# **SERVICE LETTER NUMBER 172**

#### 8750A BULKHEAD 9 CRACKING

By: RCG	Aircraft Makes/Model(s):		Note(s):
Approved: JRS		Float Model(s): 8750A	Mandatory Compliance Service Letter P/N 1008990
<b>Date:</b> 6/21/2017	Cessna 208 Cessna 208B		
Rev: B	0000Hd 200D		ECO 25123

# **WORK INSTRUCTION**

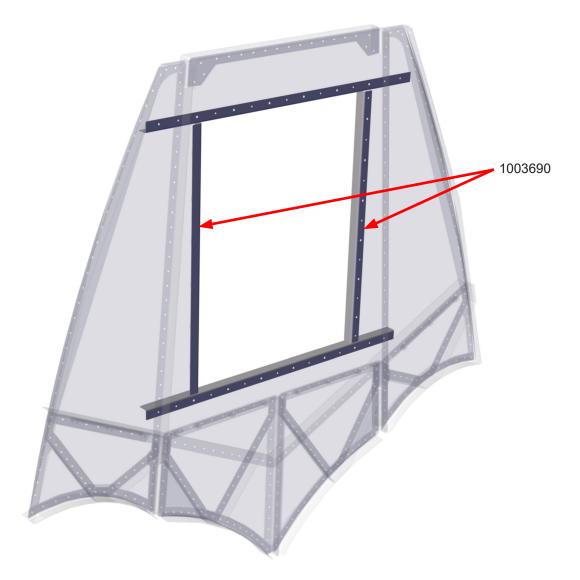
Cracking has been found on the 1006080 Bulkhead 9 Main Panel. The 1003690 Vertical Stiffeners have been revised to include a flange that will be riveted to the Horizontal Stiffeners for additional support

- 1. Gain access to the bulkhead 9 assembly through the aft baggage compartment and remove 1003688 Bulkhead 9 Access Panel. Discard (24) AN526-832R6 screws
- 2. Drill out (2) 1003690 Vertical Stiffeners

3. Inspect 1006080 Bulkhead Main Panel for cracking. If cracking is found, contact Wipaire Customer Service to receive additional instruction for repair. If no cracking is found, proceed to the next step

- 4. Remove (2) 1006513 Nylon Nutplates from each 1003690 Vertical Stiffener (4 total)
- 5. Position (2) revised 1003690 Vertical Stiffeners and (4) new 1006513 Nylon Nutplates where shown. Cleco in position and rivet through 1006080 Bulkhead 9 Main Panel

6. Backdrill through the 1003689 Horizontal Stiffeners in the 4 locations shown using a #30 drill bit

- 7. Rivet 1003689 Horizontal Stiffeners to 1003690 Vertical Stiffeners in the locations previously drilled
- 8. Reinstall 1003688 Bulkhead 9 Access Panel using Crest Midwest Industries Black Strip Caulk P/N CRSXSB (or equivalent) and new (24) AN526-832R6 screws
